**Watts Bar Unit 1
Technical Evaluation Report on the
IPE Front-End Submittal**

**Contractor Step 1 Audit Report
NRC-04-91-066, Task 12**

**By:
Science and Engineering Associates, Inc.**

**Prepared for the
Nuclear Regulatory Commission**

Figure II.1.2.5-1. 2 Inch LOCA

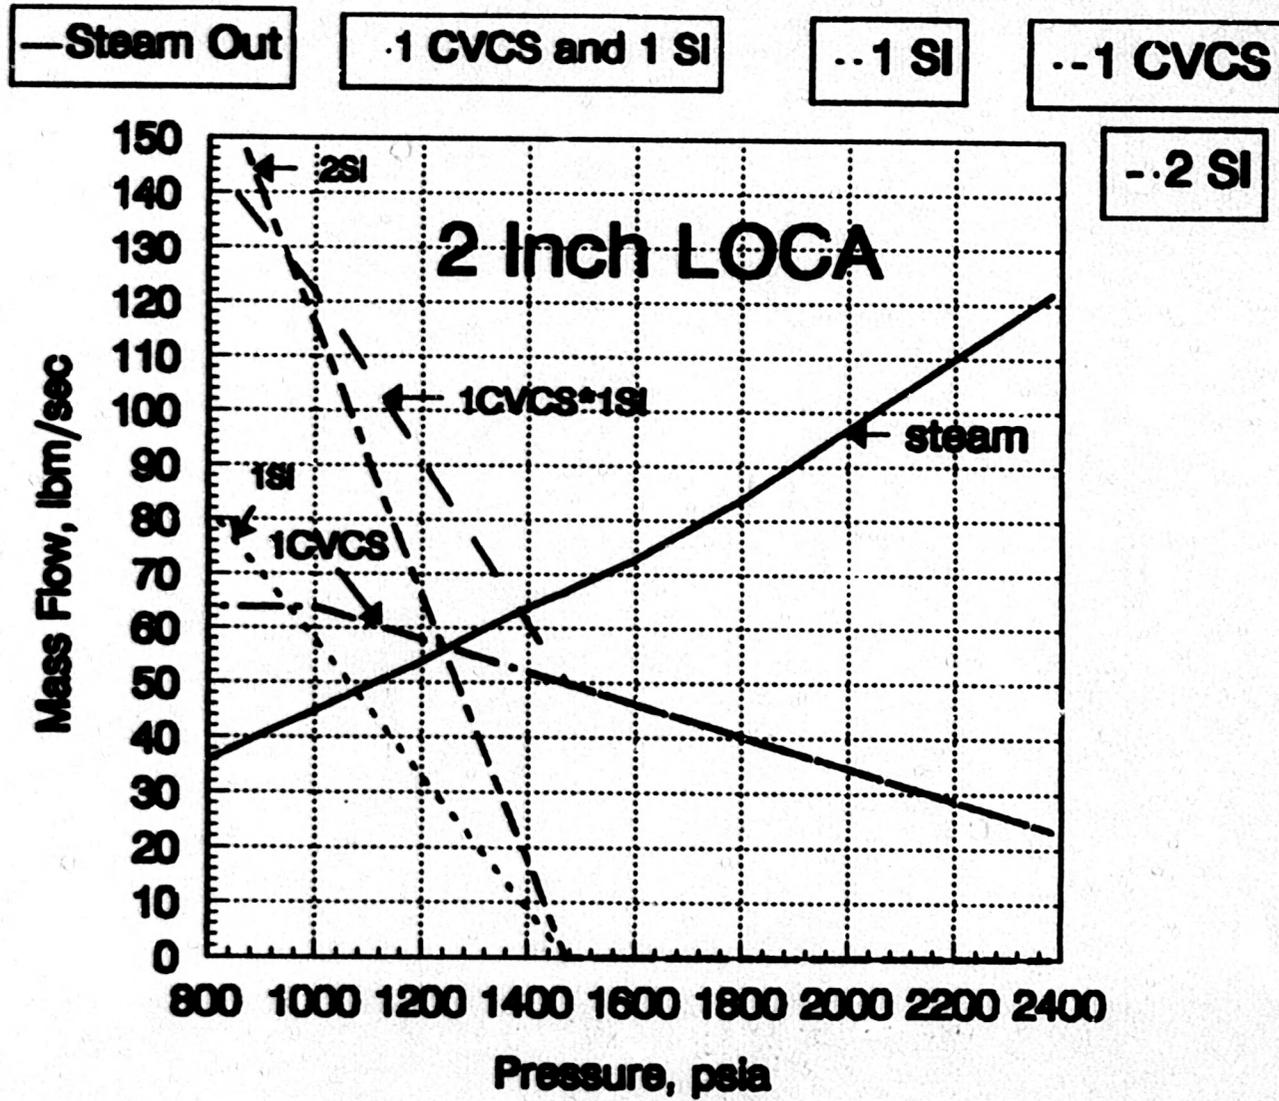
The IPE success criteria for a small LOCA (less than 2 inches) is one of four CVCS/SI pumps, and for a medium LOCA (2 to 6 inches) the success criteria is two of four pumps. The FSAR success criteria is one CVCS pump and one SI pump. The IPE success criteria for small and medium break LOCAs deviates from the FSAR success criteria.

For example, consider a two inch break. The IPE success criteria indicate that no steam generator cooling is needed for this size break (the minimum medium size LOCA). Generally credit is taken for cooling using the initial stored inventory in the steam generators, but is not taken for continued feedwater to the steam generators.

$$\dot{Q} = \dot{m}(h_o - h_i) \quad (\text{Eqn. A})$$

for a mass and energy balance with no heat removal by the steam generators and steaming out the break, where \dot{Q} is the decay heat, \dot{m} is mass flow of water in, and steam out, h_o is specific enthalpy of steam out, and h_i is specific enthalpy of water in. Figure II.1.2.5-1 shows steam mass flow rates for a 2-inch hole and pump head flow rates for the cases of 1 CVCS pump, 1 SI pump, 1 CVCS and 1 SI pump, and 2 SI pumps, using data from Section 6.3 of the FSAR. Using the match point for 1 CVCS and 1 SI pump, equation (A) implies that the decay heat is 0.022 of full power; using the match point for 1 SI pump the decay heat is 0.017 of full power; using the match point for 2 SI pumps the decay heat is 0.019 of full power. Based on the Standard Review Plan decay heat curve, 0.022 is reached at 25 minutes, 0.017 is reached at 50 minutes, and 0.019 is reached at 33 minutes. Assuming a steam generator dryout time of about 30 minutes, this implies that both a CVCS and a SI pump are sufficient for a 2-inch equivalent small LOCA; however, a single SI pump may be pushing the limit. (It should be noted that some Westinghouse four loop plants, such as South Texas, have a significantly higher

capacity SI pump with a higher shutoff head and, for these plants, the FSAR licensing analyses does not require the CVCS pump.)
